SITE PLAN AMENDMENT  
HIGHLINE VILLAGE  
CITY OF AURORA

**OVERALL UTILITY PLAN**

**DETAILED GRADING 1**  
DRAWING NAME: 1243-CONST-DET-GR.dwg  
SHEET NO. 5 OF 15

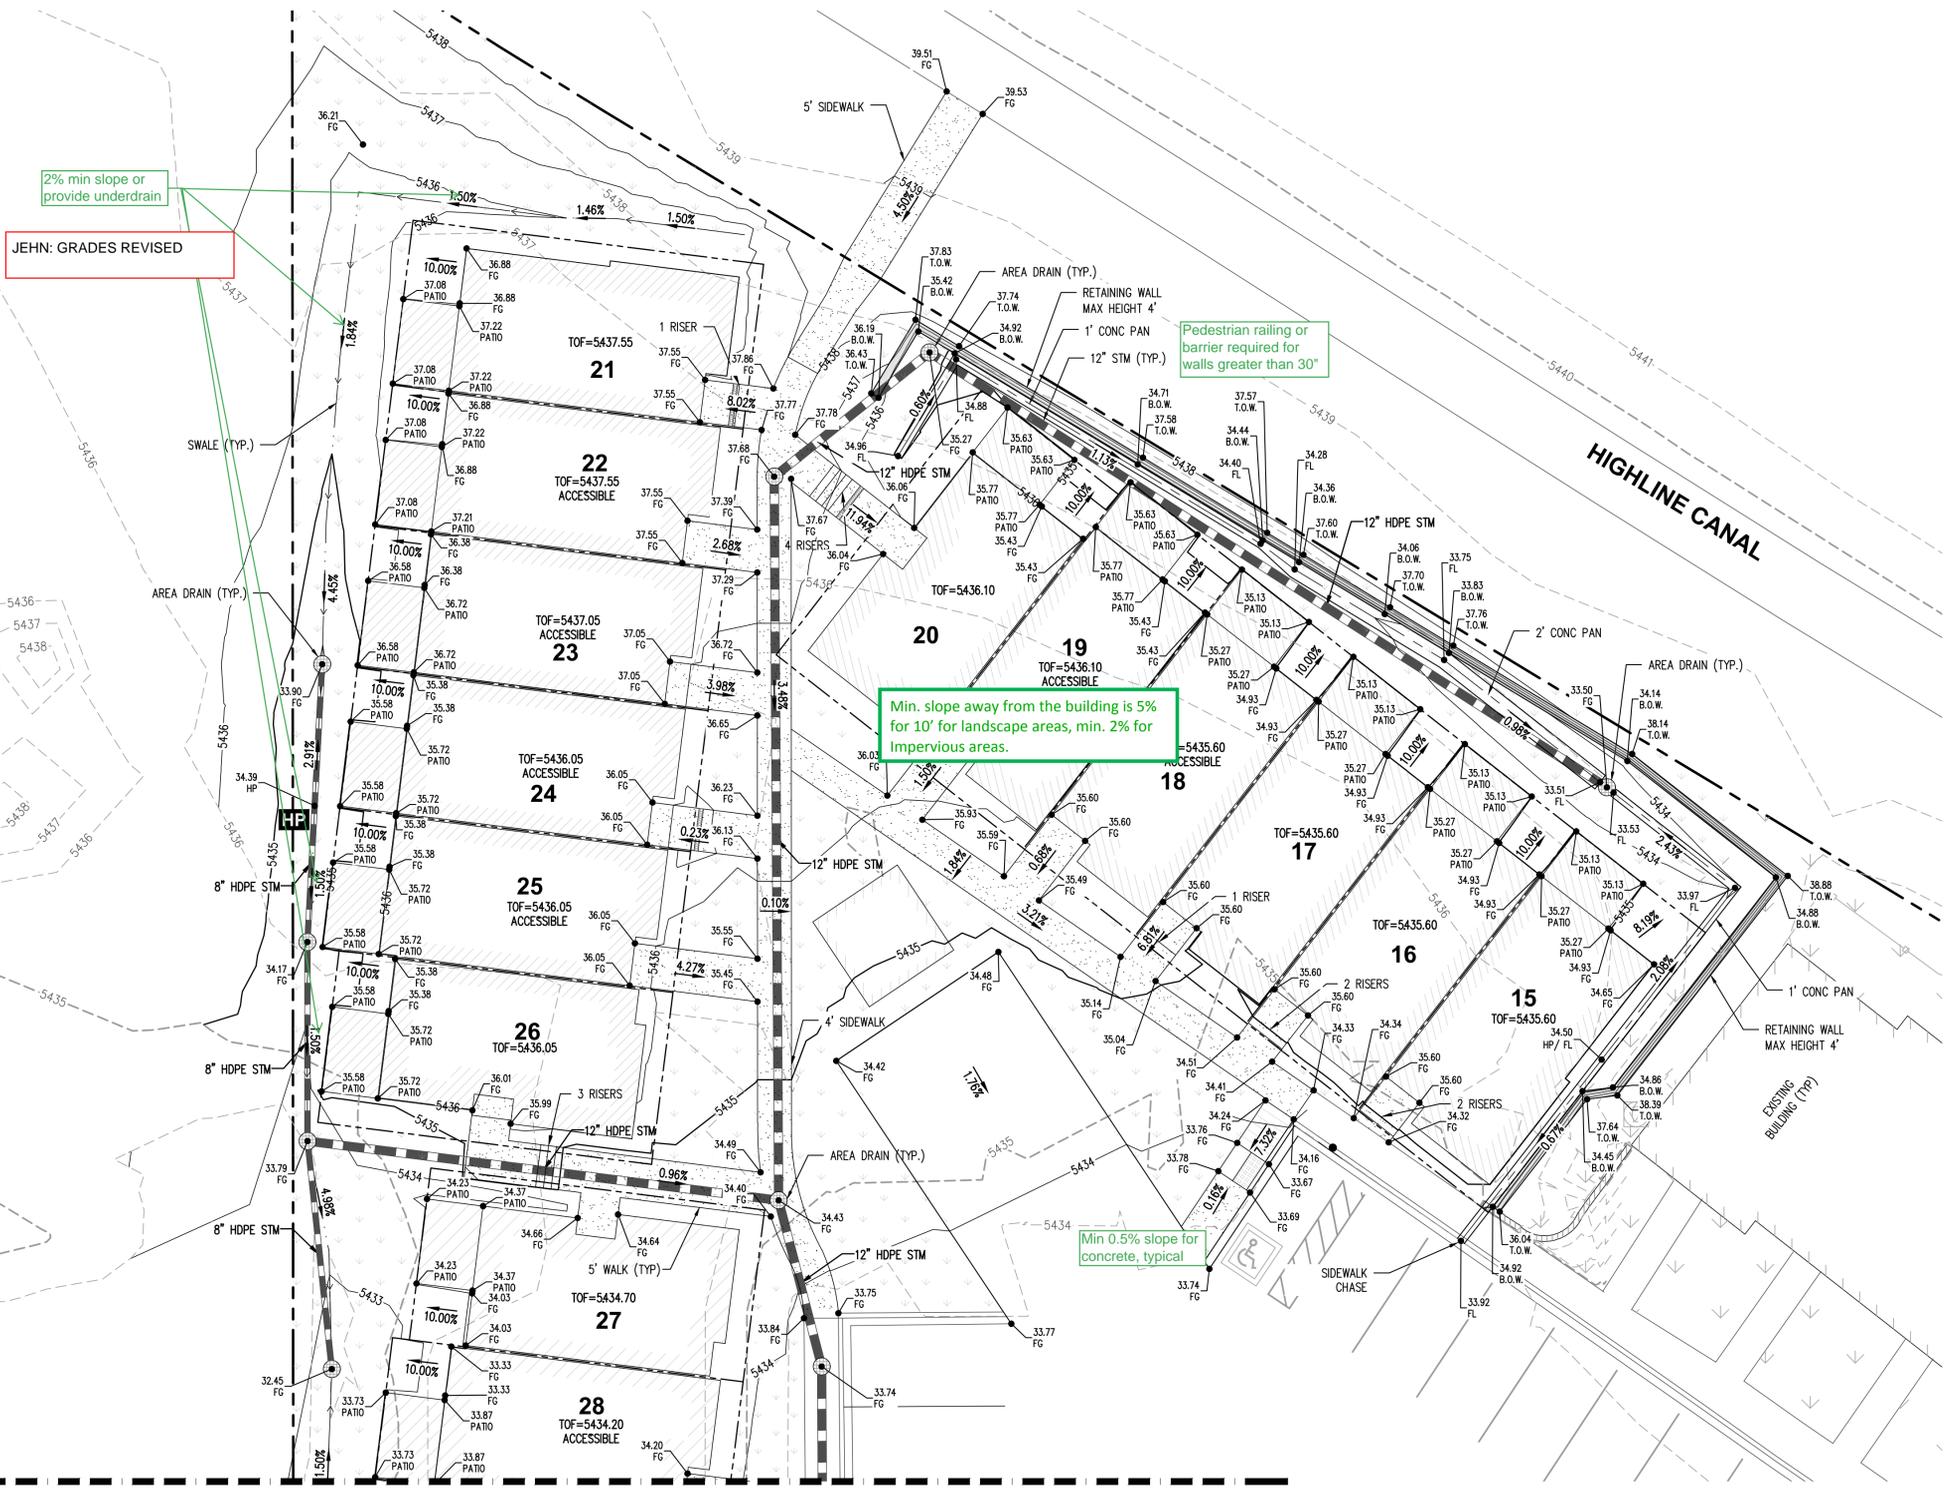
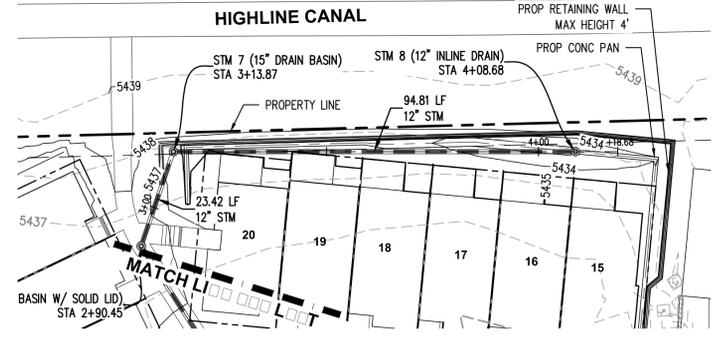
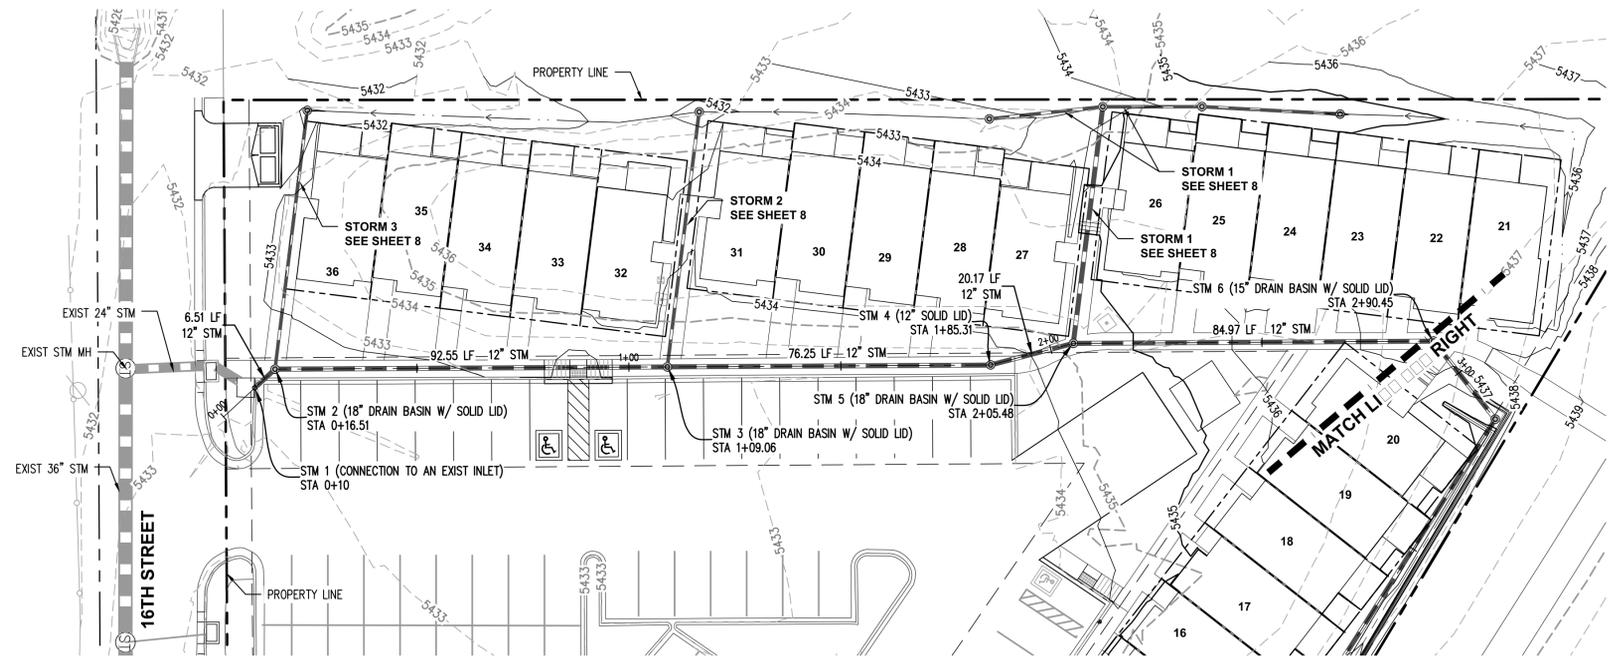
2% min slope or provide underdrain

Pedestrian railing or barrier required for walls greater than 30"

Min. slope away from the building is 5% for 10' for landscape areas, min. 2% for impervious areas.

Min 0.5% slope for concrete, typical

Add a note indicating if the storm sewer system is public or private and who will maintain it.

JEHN: GRADES REVISED

STORM PLAN AND PROFILE 1

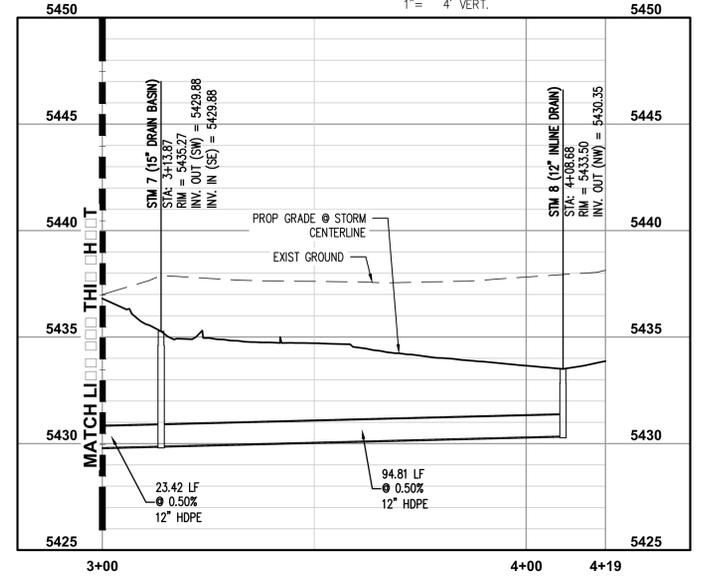
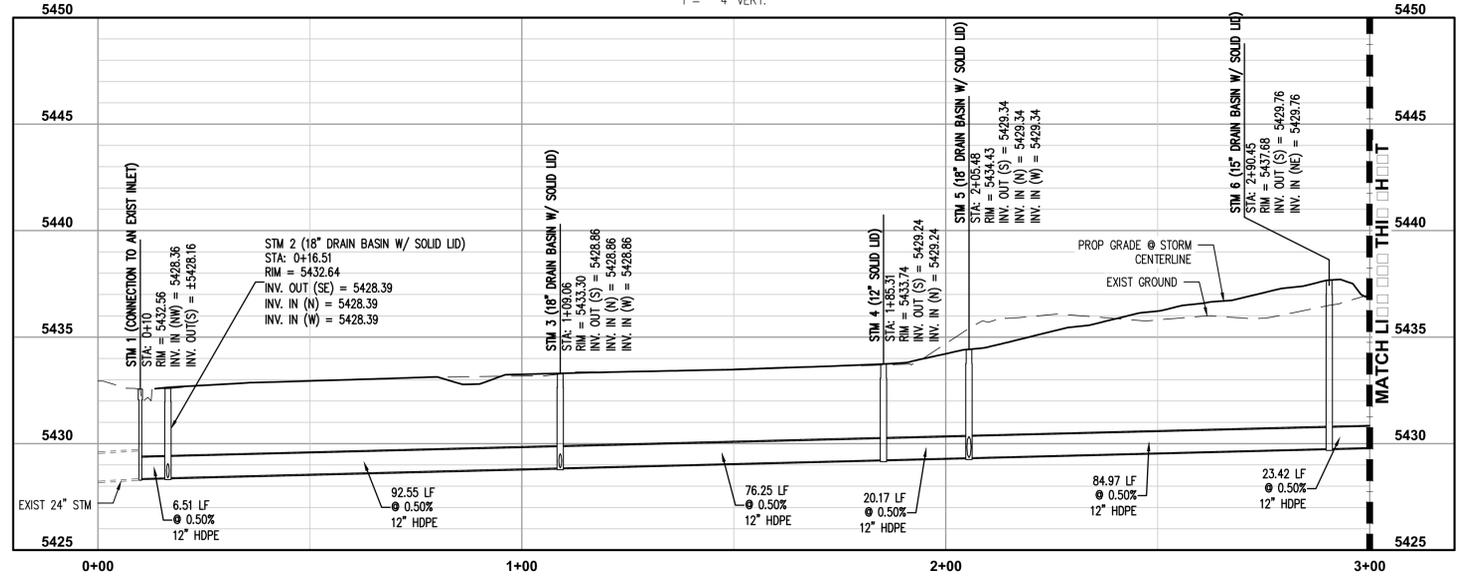
Storm plan and profiles are not part of the site plan. Please remove and include in the civil plan submittal

Storm sewer is also private. Please add to note.

JEHN: SHEET WITHDRAWN

STORM PLAN AND PROFILE 2

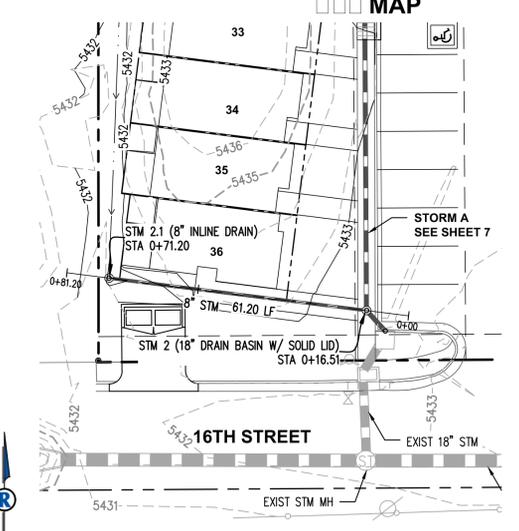
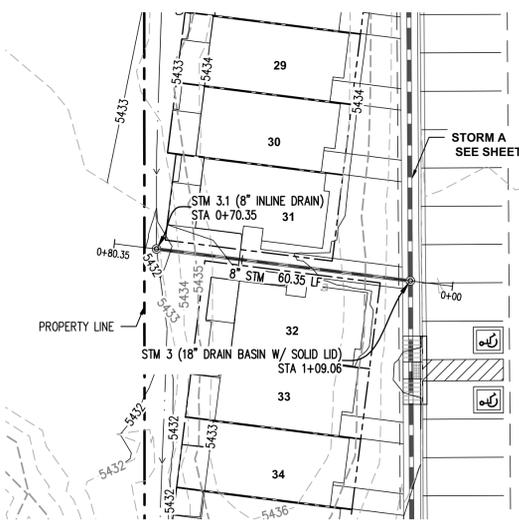
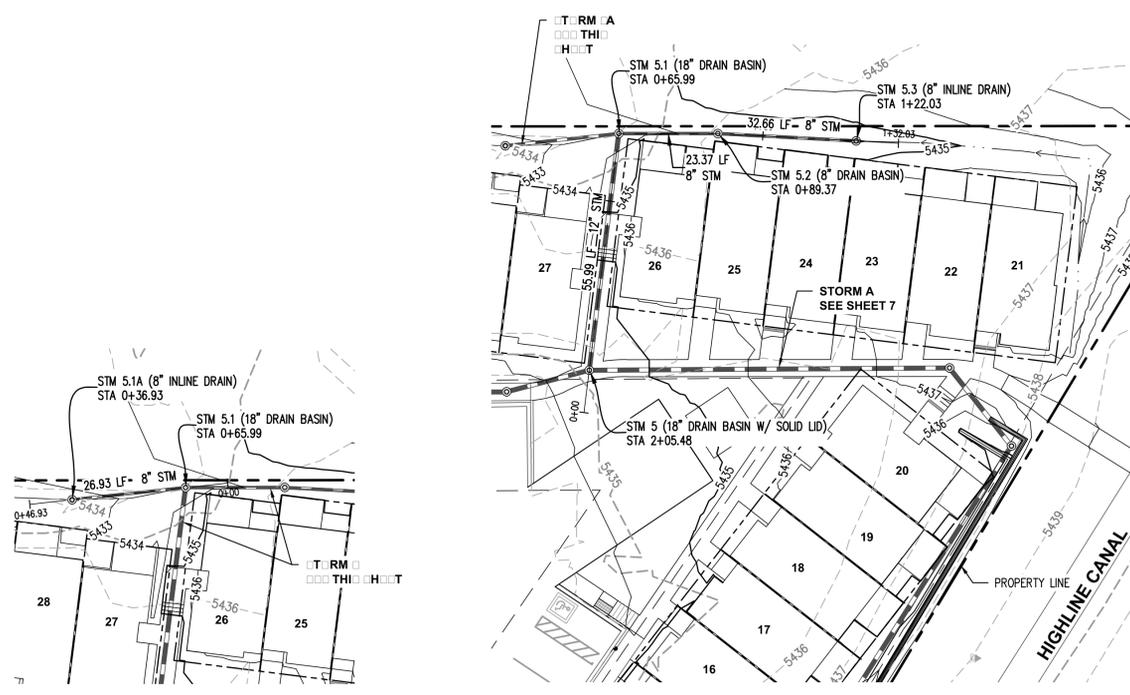
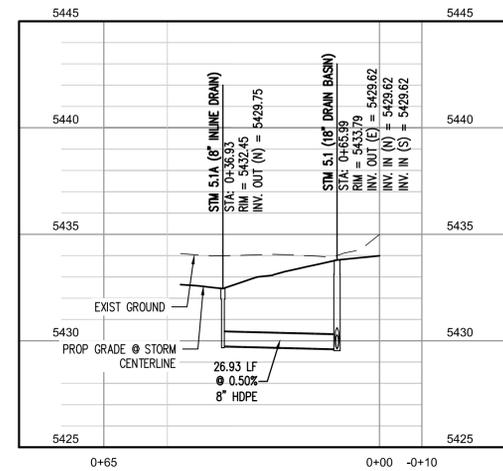
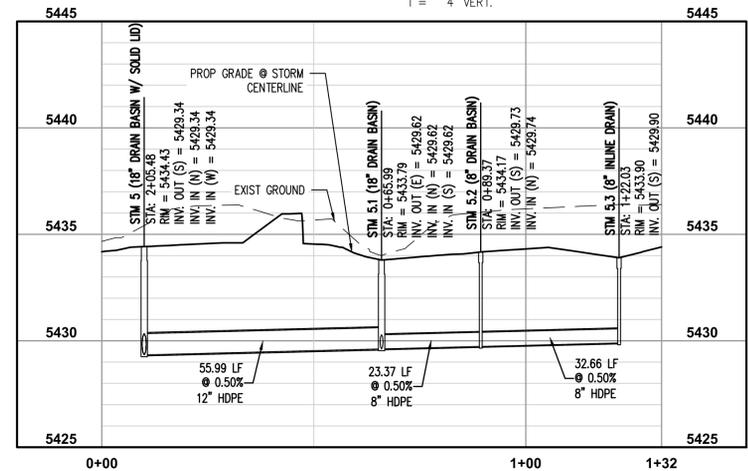
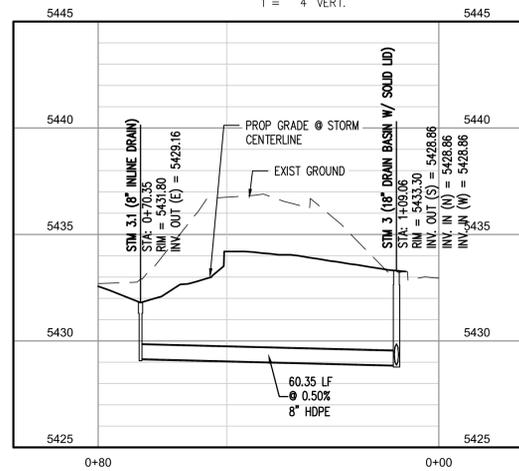
Storm plan and profiles are not part of the site plan. Please remove and include in the civil plan submittal

JEHN: SHEET WITHDRAWN

ITIG TR  
PLA

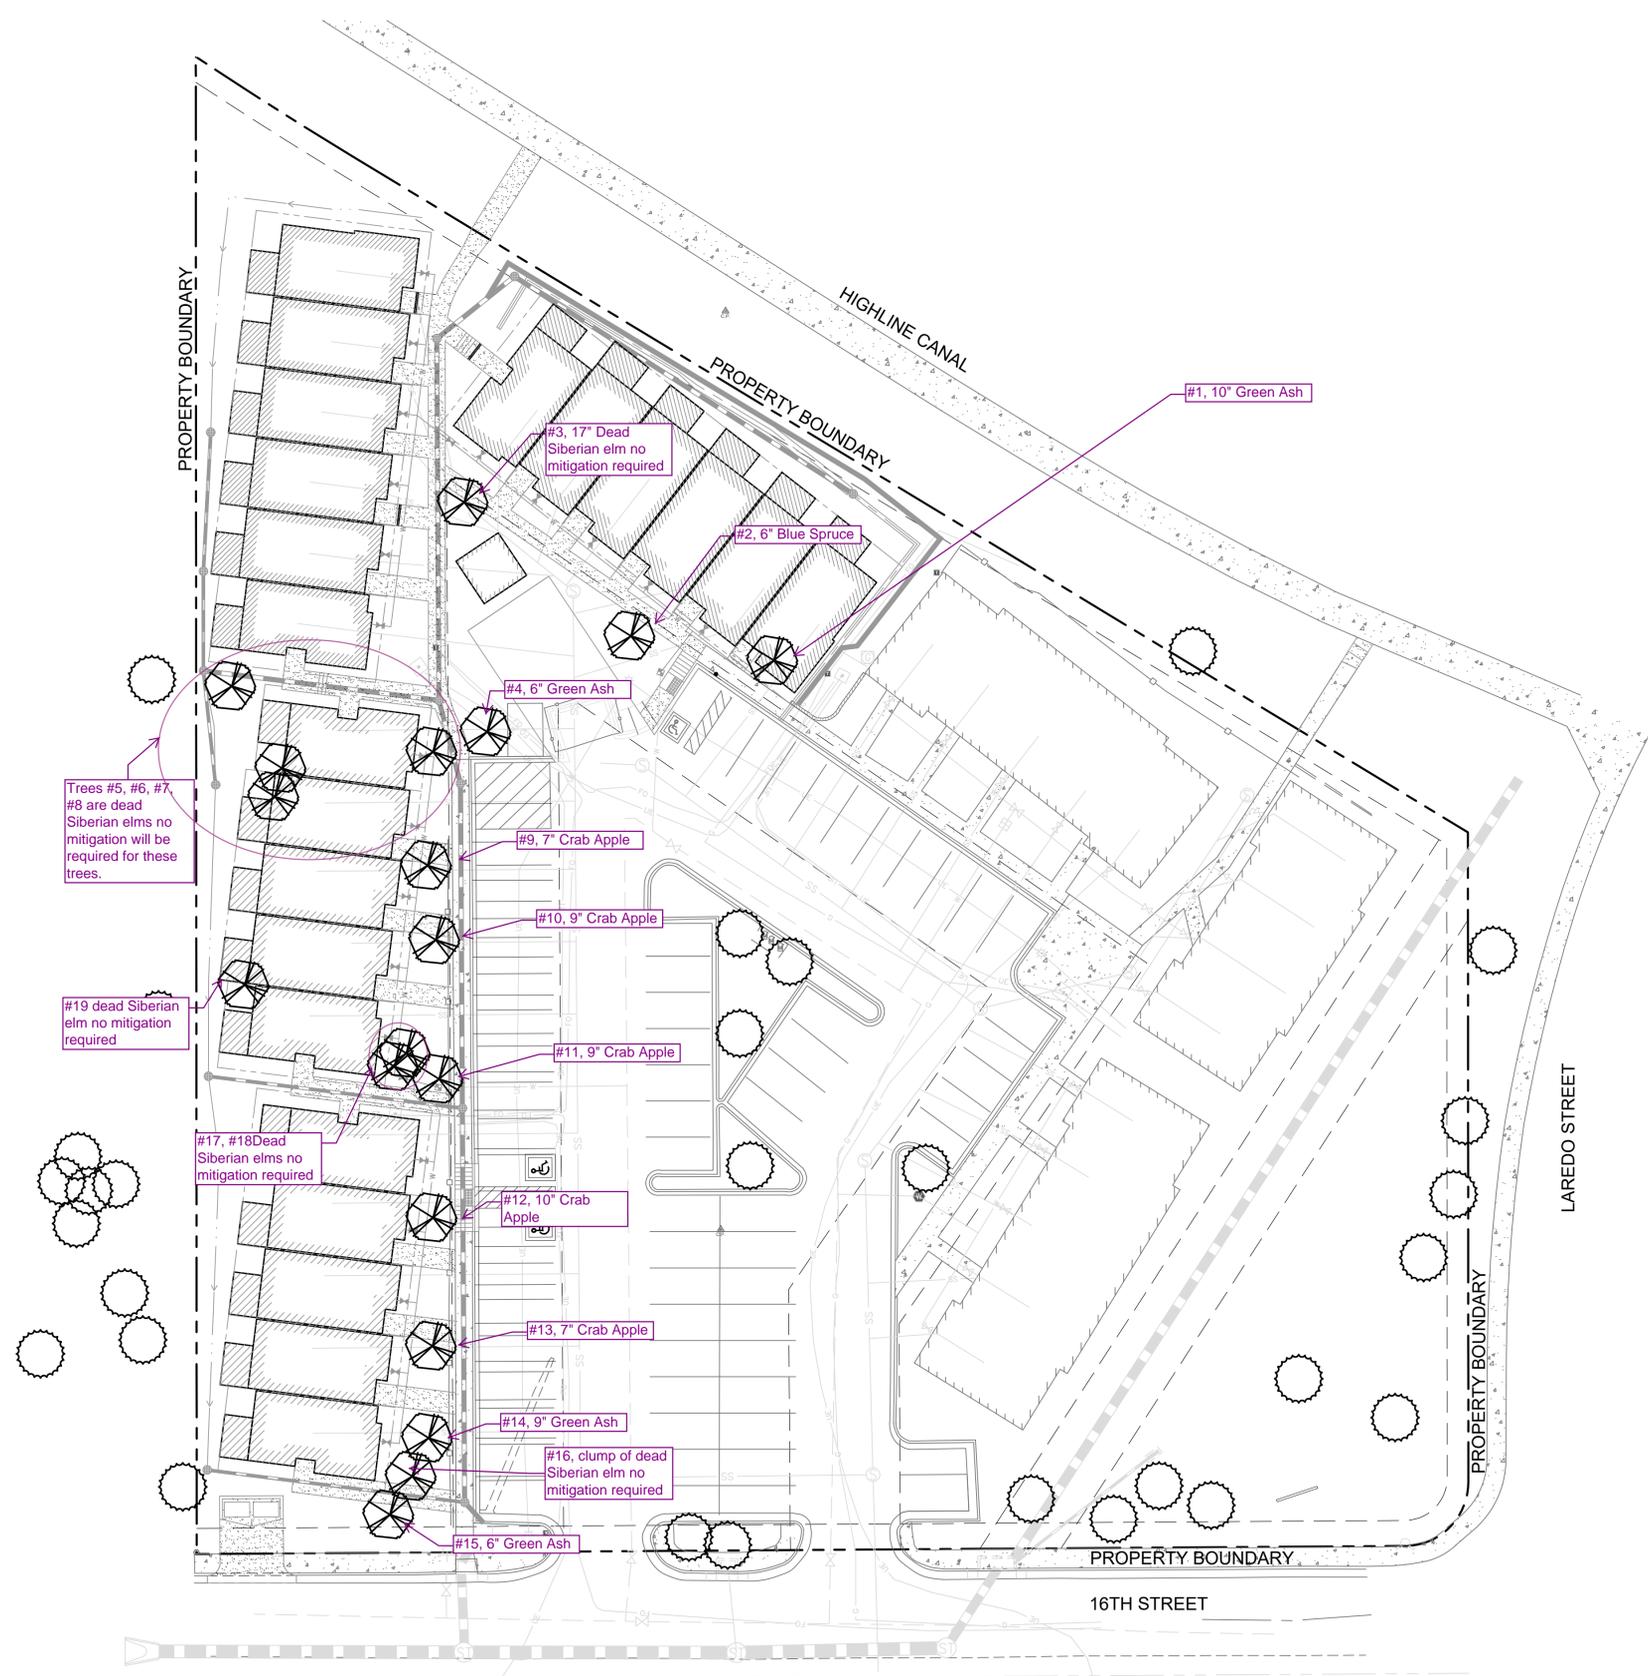
Any trees that are preserved on the site during construction activities shall follow the standard details for Tree Protection per the current Parks, Recreation & Open Space Dedication and Development Criteria manual. Parks, Recreation & Open Space Dedication and Development Criteria manual. These notes shall be added to the plan.

Please show a tree mitigation chart on the landscape plan taken from the Landscape Manual page 29. If payment will be made into the Tree Planting Fund, add another column to the chart indicating the payment amount that will be made. If trees will be planted on the site, please show a symbol indicating trees that are specific to tree mitigation.
